## Revised Comments on Proposed Amendments of the Bay-Delta Water Quality Control Plan's Compliance and Baseline Monitoring Program

November 30, 2004

Figure 3: Comparison of Greens Landing (C3) and Hood (C3A) Monitoring Stations (July 2003-June 2004, 16 constituents, Deming regression and Bias plots: no significant differences between stations (see Triboli et al, IEP newsletter 2003(4):13-24 for statistical analysis techniques))

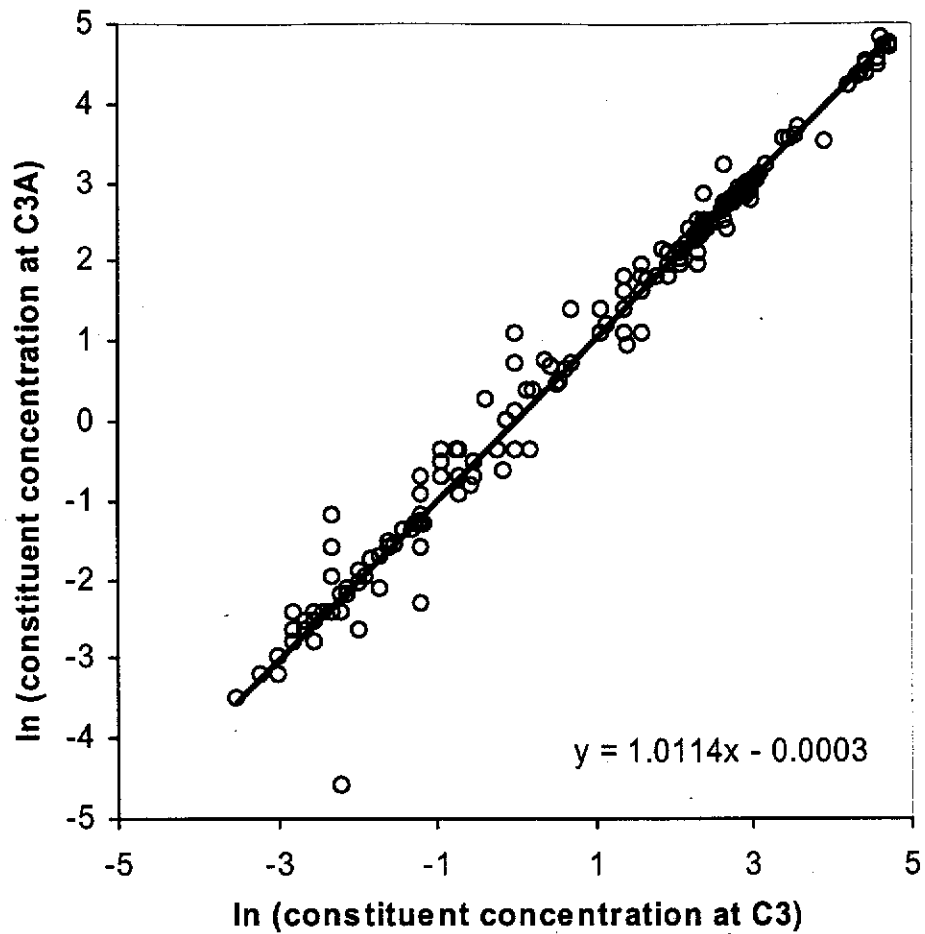
- 17 monitoring elements would remain unchanged
- 4 monitoring elements would remain operationally unchanged but would be identified with new station numbers
- 8 historically monitored elements would be reestablished
- 1 historically monitored elements would be removed
- 8 baseline monitoring elements would be added
- 2 baseline monitoring elements would be moved to consolidate two neighboring stations (Hood & Greens Landing) for greater sampling efficiency. Comparisons of monitoring data from these two stations show no differences (Figure 3 of this document).

Figure 4: Proposed Revision of Figure 2 of the 1995 Bay-Delta Water Quality Control Plan

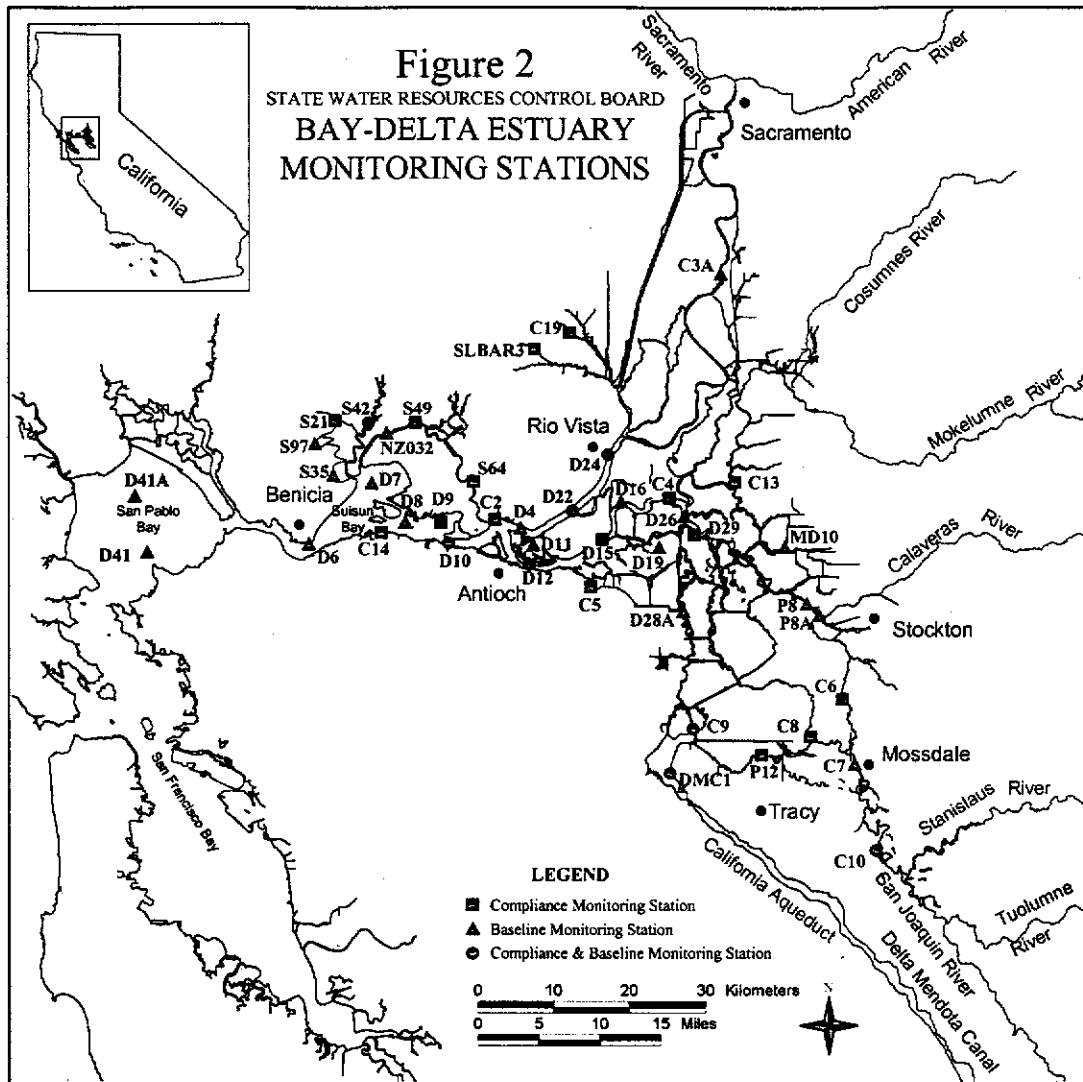
The amendment of Figure 2 of the Plan would reflect the previously proposed changes to the monitoring plan. Figure 4 of this document shows the proposed revision of the Plan's Figure 2.
